**Consultation Response from KC, Highways Development Management (HDM)**

**2022/92471 Heckmondwike Hub Bus Station, Royle Fold, Heckmondwike, WF16 0HW**

**Redevelopment of Heckmondwike Bus Station including a new concourse building with waiting room, Changing Places WC, driver offices, 6 No. bus stands, landscaping, and associated works**

**RECOMMENDATION: Further information required**

The above application relates to the re development of the bus station site. The proposed layout is shown on site layout plan TCF-WSP-KIR-HECK-DR-CH-01 Rev P06 dated June 2022.

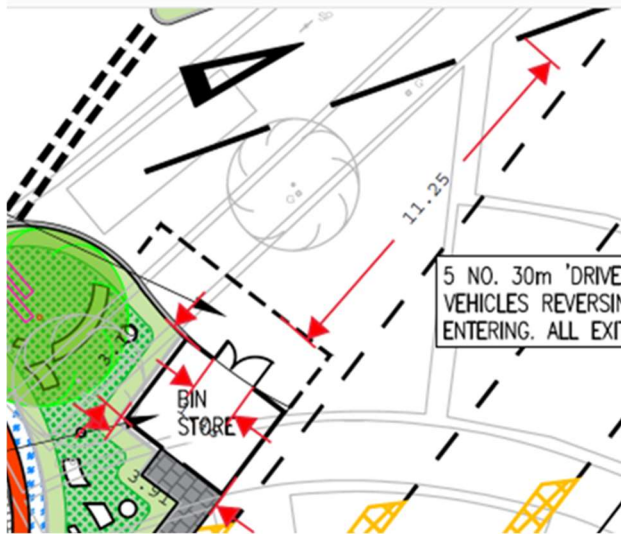
- The plan shows a new bin store/ compound on site. It is assumed that the operators will have experience of the amount of waste currently generated and the store has been scaled to accommodate an appropriate number of wheelibins. Guidance indicates the floor space for a 1100ltr wheelibins is 1575mmx1190mm with space to manoeuvre the bins within the store so the bin store dimensions would depend on configuration within the store. Dimensions of the store are approximately 3mx3,9m with a opening of 1.4m that should be sufficient for at 1100ltrs wheeliebin to pass through. The waste store should be constructed with an impermeable floor surface. Guidance on the floor footprint for wheeliebins and specification on construction requirements including screening can be found in the [Waste Management Design Guide for New Developments \(kirklees.gov.uk\)](https://www.kirklees.gov.uk/waste-management-design-guide-for-new-developments)

- The drag out distance for wheeliebins from a Bin store/ premises to the collection vehicle should preferably be under 15m with a drop kerb from the store level to the RCV loading point. Any waste storage area should be secure to prevent theft, unauthorised use/ fly tipping or rough sleeping.

- It appears that RCV's will use the bus lane into the site to access the waste storage area. There looks to be just sufficient space to enable an RCV (11.22m) to park with the cab facing the waste store with waste transferred to the back of the vehicle for loading. If using George Street the RCV may reverse to the bin store. Reversing of RCV's is recognised as a health and safety risk both to collection staff and members of the public.
